Engineer Approved Exceptions Request

Re: Engineer Approved Exceptions
Onsite Wastewater System Practices
Use of Distribution Box in Soil Absorption Field

Re: Engineer Approved Exceptions
Onsite Wastewater System Practices
Inspection Port with 90-degree PVC Elbow

Re: Engineer Approved Exceptions
Onsite Wastewater System Practices
Chamber Bed System Design

| <i>CHAMBER BED</i> | |

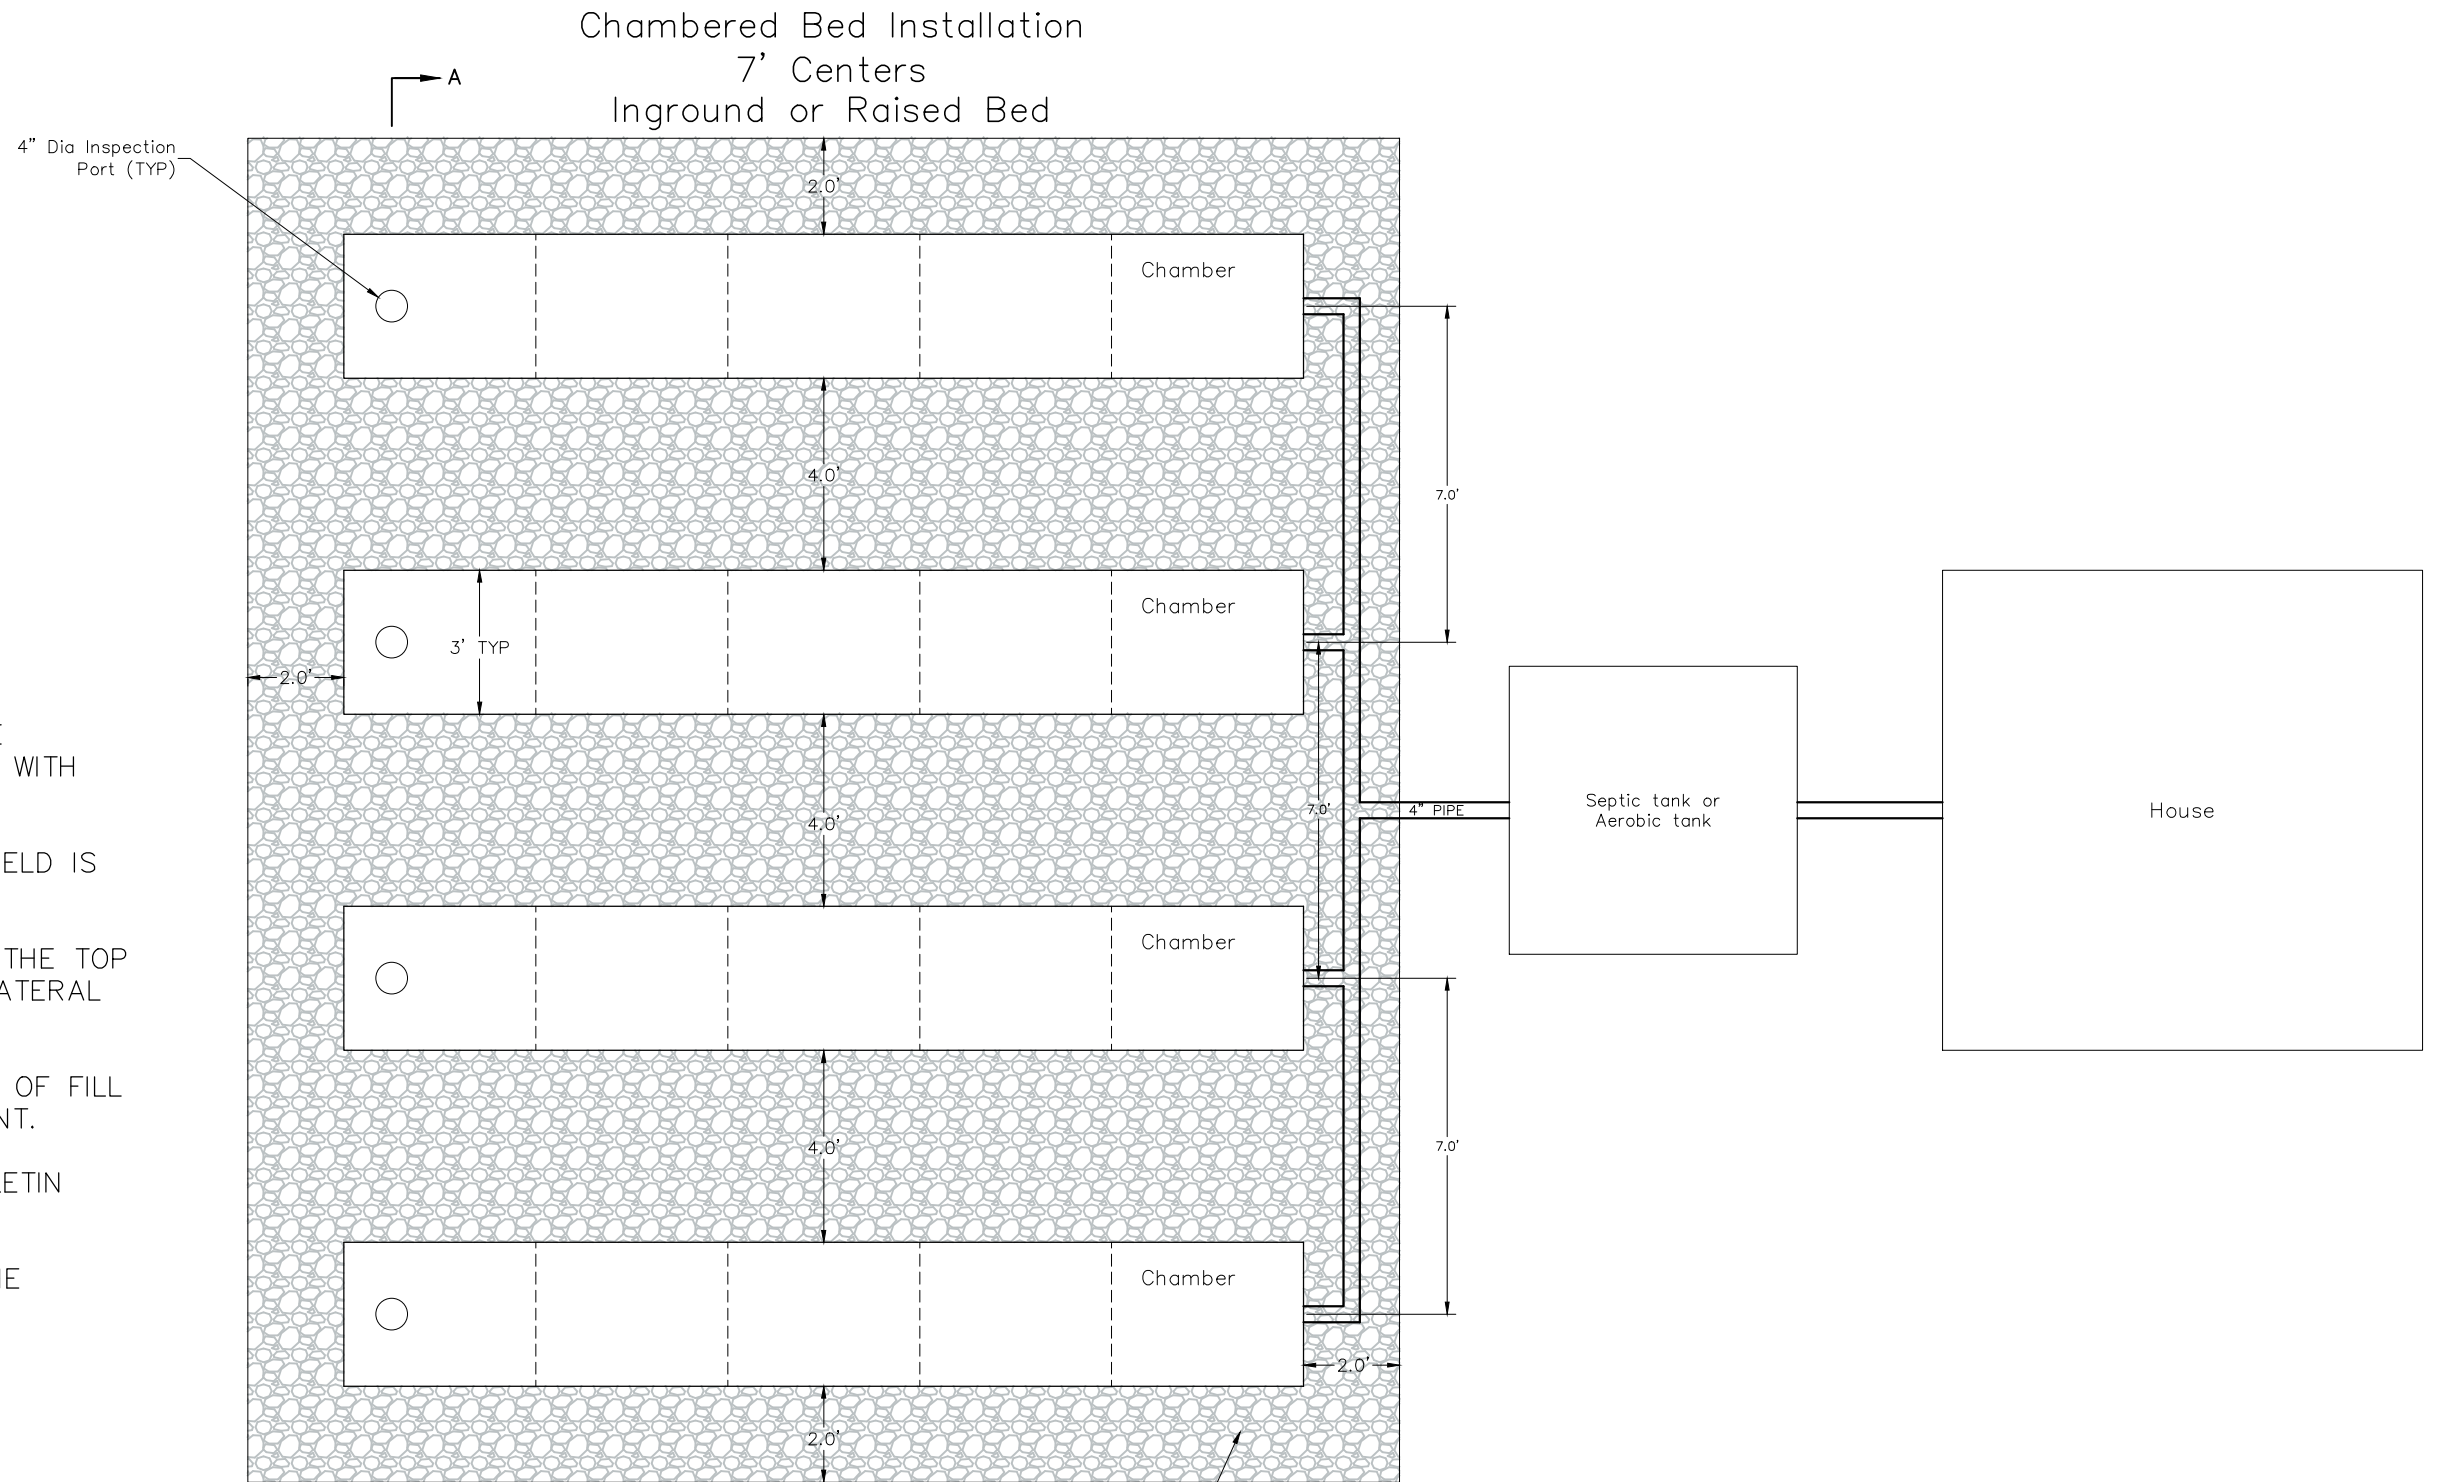
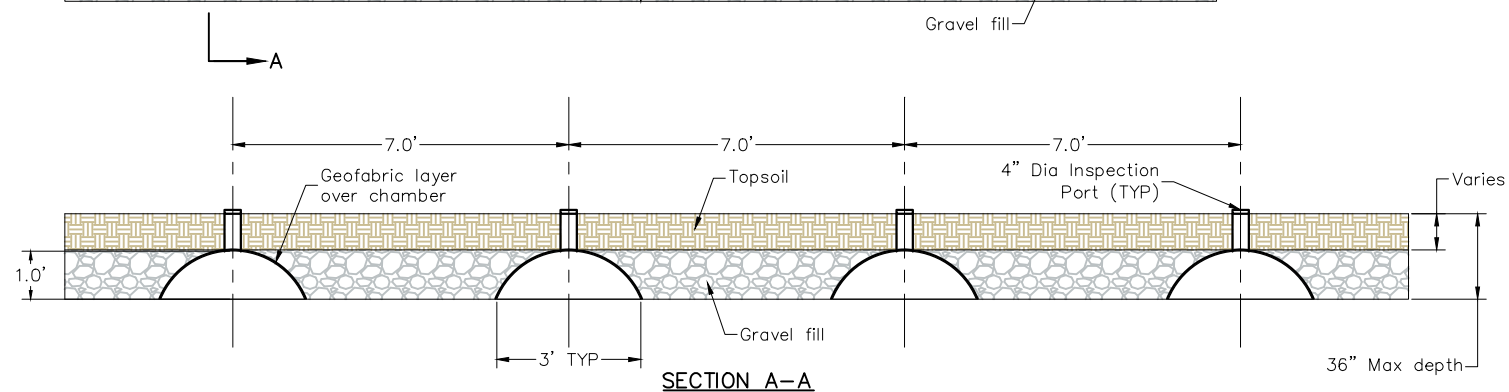
Upon engineering evaluation and review, it is determined that a 7'-0" center to center spacing (see attached drawing) and 2'-0" space around sides meets all requirements and is approved in lieu of the 3' – 6' spacing recommended in the KDHE Environmental Health Handbook. It is determined that the 7'-0" spacing provides better oxygen transfer in the center of the bed which reduces chance of creating anaerobic conditions and thicker biomat growth beneath the chambers. Per the attached drawing, gravel rock fill and geotextile fabric shall be per KDHE Bulletin 4-2.

This approval applies to both inground and raised bed installations.

Typical Absorption Bed Layout

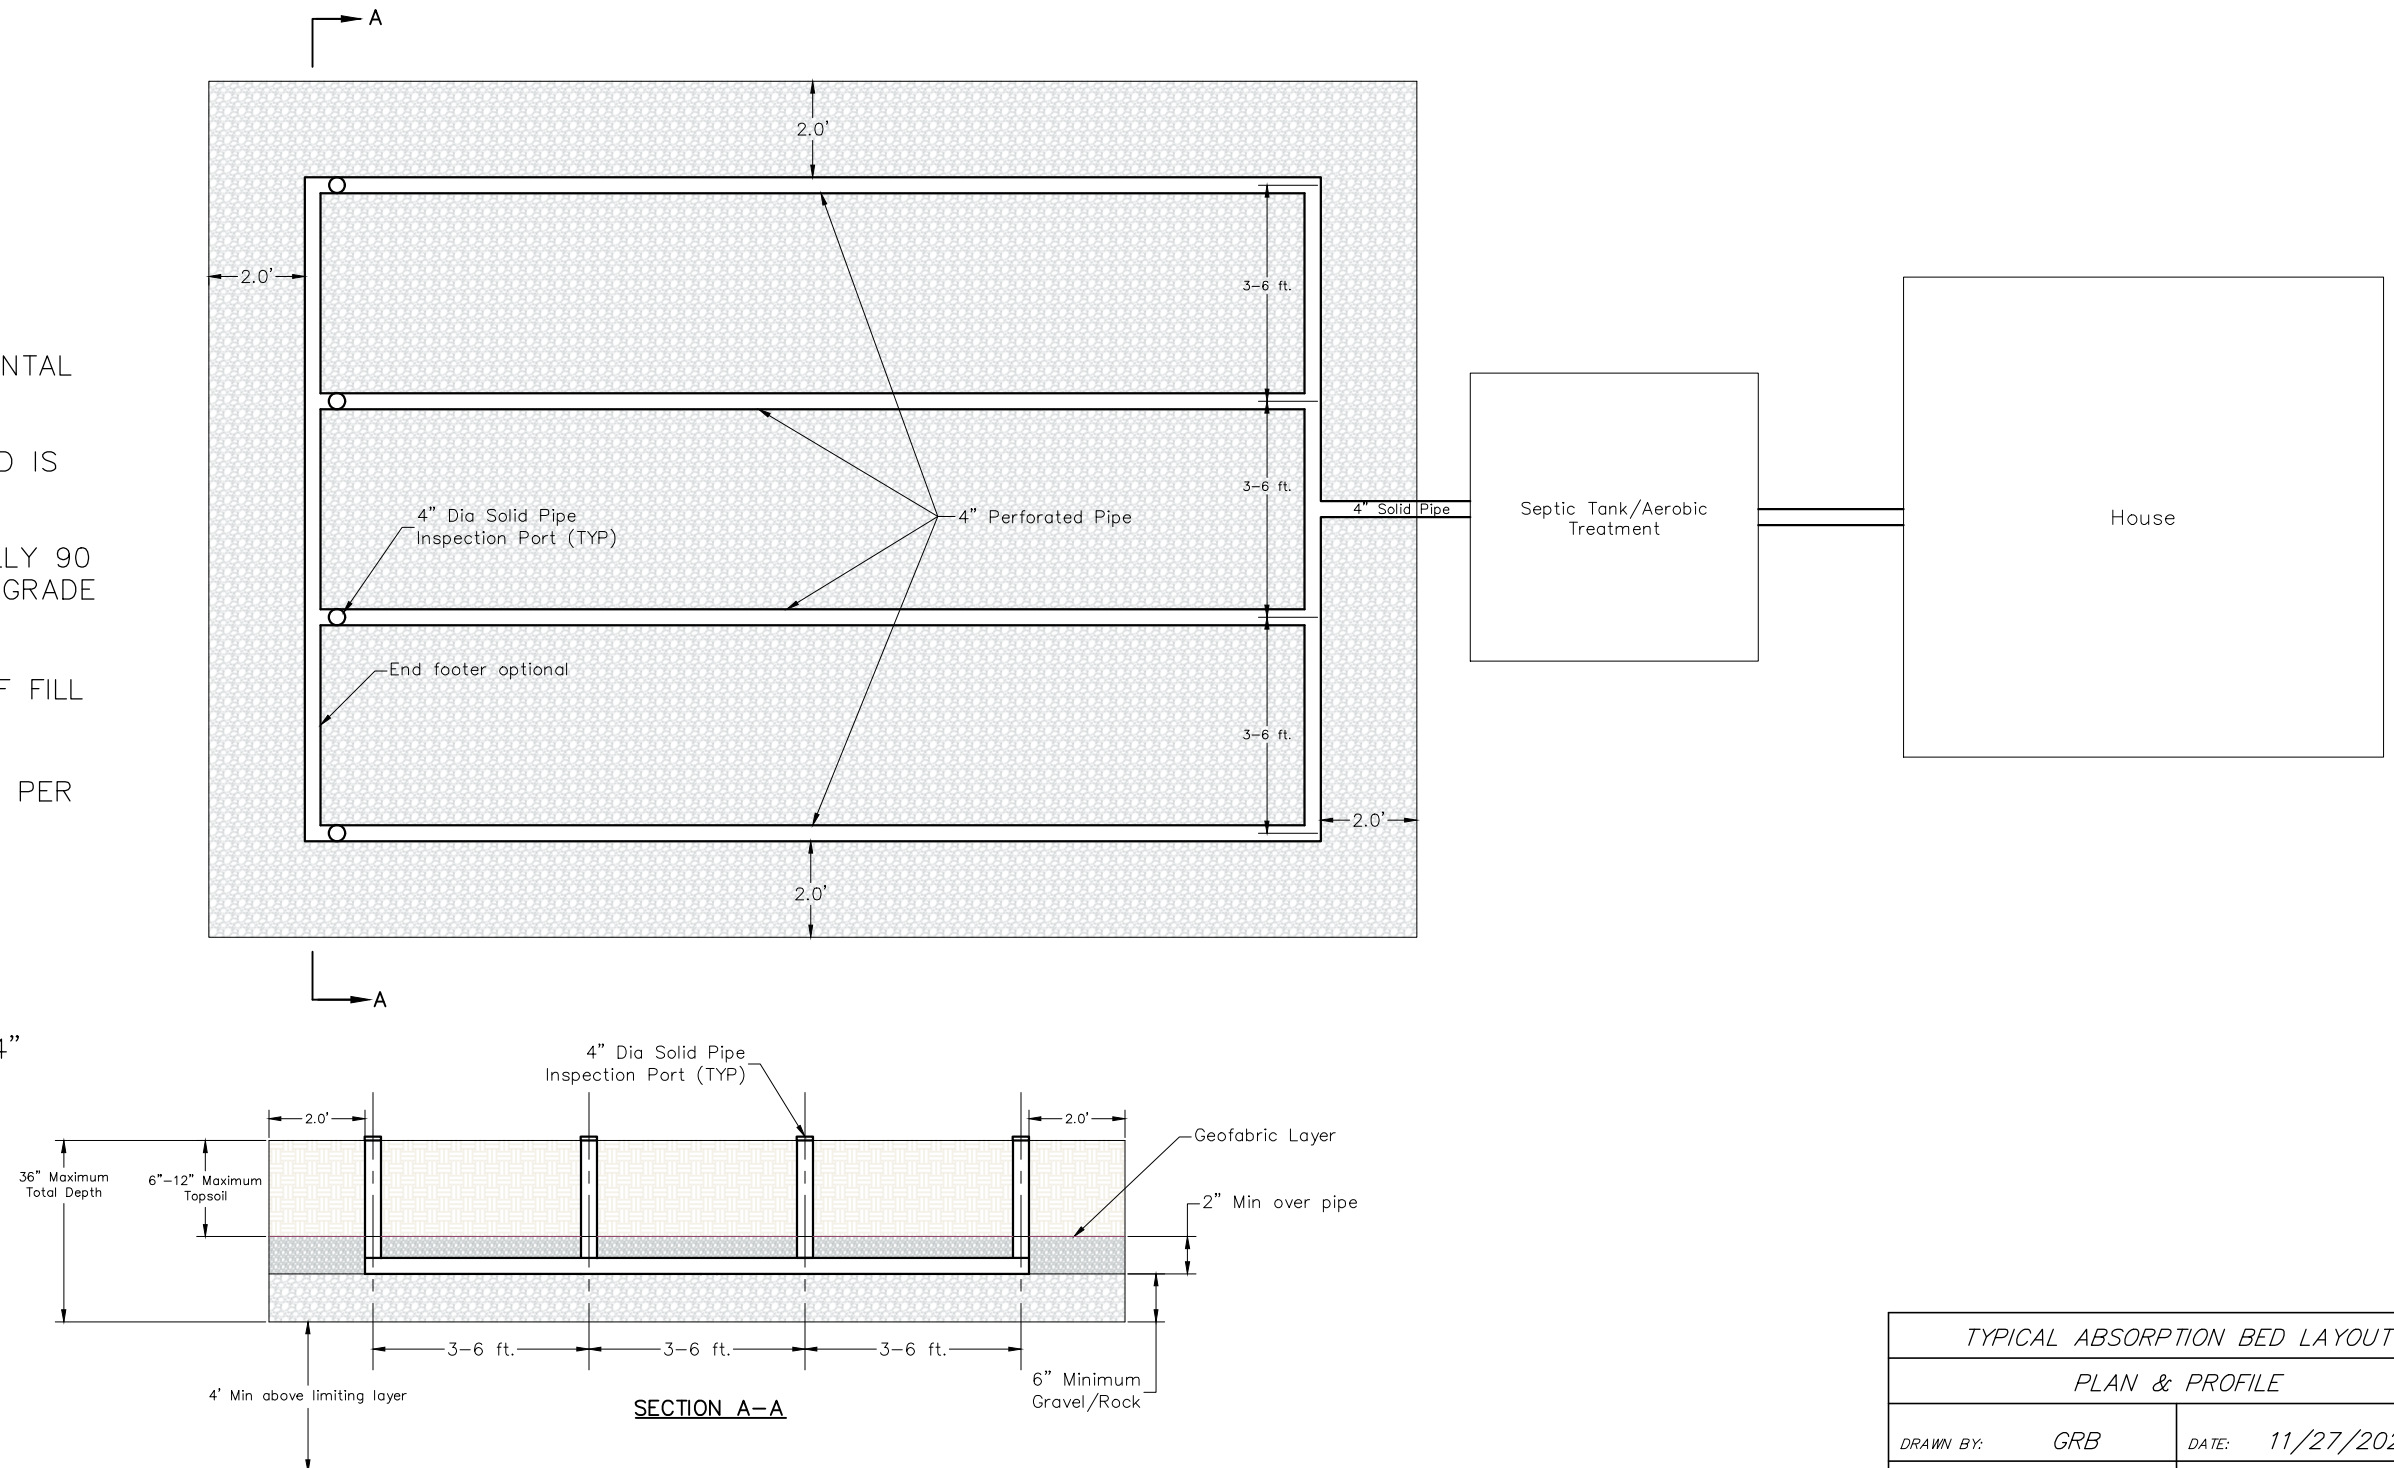
Re: Engineer Approved Exceptions
Onsite Wastewater System Practices
Typical Absorption Bed System Design

Upon engineering evaluation and review, it is determined that a typical absorption bed system (pipe and gravel) is approved if constructed according to the attached drawing with 3'-6' pipe spacing and 2'-0" space around sides. As indicated, gravel rock fill and geotextile fabric shall be per KDHE Bulletin 4-2. This drawing and approval applies to both inground and raised bed installations.
